The Town of Erie

Memo

To: Matt Janke and Chris Elliott, MR Erie, LLC
From: Hannah Hippely
Date: January 25, 2019
Re: SK-000978-2018 – Spring Hill Sketch Plan Application
cc: Deborah Bachelder

Comprehensive Plan Map

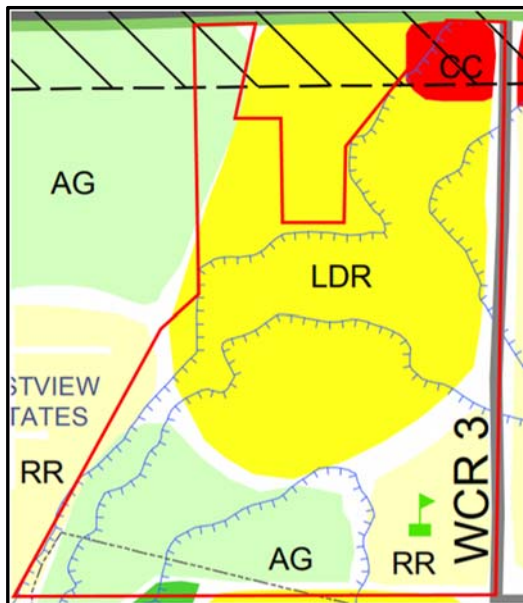
- a. All of the uses proposed by the sketch plan are permitted within the LR Zone District and the zoning allows for all of the land use designations of the Comprehensive Plan.
- b. The proposed sketch plan is not consistent with the Comprehensive Plan Agriculture (AG) land use designation for this property.
 - i. Approximately 70 acres in the south portion of the property is designated as Agriculture (AG) on the Comprehensive Plan. According to the Comprehensive Plan farming, ranching, and other agriculturally related uses and very low density rural residential uses

- are appropriate in this area. Also, lands designated Agriculture “serve a vital role in defining the history and character of Erie and should be maintained where viable, to serve as gateways and buffers, preserve vistas, and retain the desired character of the Town.” Within this area the plan shows the western edge, the areas adjacent to the western two ditches (Lower Boulder Ditch and the Boulder/Weld Ditch), as open space and develops the remainder at a density consistent with an LDR land use designation.

- ii. The LR Zone Designation does not negate the need for the subdivision to be consistent with the Comprehensive Plan. A Comprehensive Plan land use map change would need to be approved if the subdivision is not redesigned to be consistent with the Comprehensive Plan.

- c. It appears that over all residential densities comply with the Comprehensive Plan and Zoning Map.
 - i. Tract Q, which is located along the western edge of the development adjacent to the rural Weld County subdivision and the south east corner of the property are two areas designated RR on the Comprehensive Plan where residential densities of 0-2 dwelling units per acre (du/ac) and gross density not to exceed 1 du/ac is expected.

- ii. The area designated as LDR on the Comprehensive Plan within the subject property is approximately 160 acres. LDR densities are expected to be 2-6 du/ac with gross densities not to exceed 4 du/ac or 640 dwellings.

- iii. The proposal includes 632 lots which is in line with the overall densities expected by the Comprehensive Plan for the developed portions of the property. At the time of preliminary plat this analysis shall be presented by the applicant to demonstrate compliance with the Comprehensive Plan density expectations as shown on the land use map.

Zoning Map

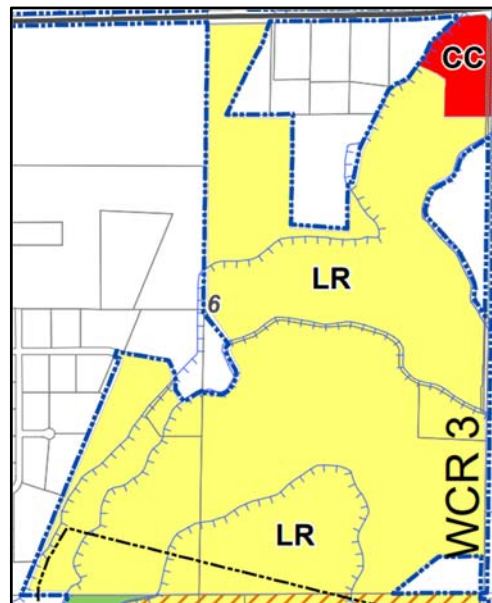
- iv. LR Zoning allows for a gross density not to exceed 5 du/ac. Gross density is the total number of dwelling units allowed based on the size and zoning designation but not taking into account the portions of unbuildable land. At the time of preliminary plat this analysis shall be presented by the applicant to demonstrate compliance with the zone district density expectations however, at this time staff estimates the allowed maximum density to be 780 units.

- d. The Comprehensive Plan and the Zoning Map show a flight cone associated with the Parkland Airport over southern portions of the property. The applicant will need to coordinate with the Parkland HOA as part of the preliminary plat process.
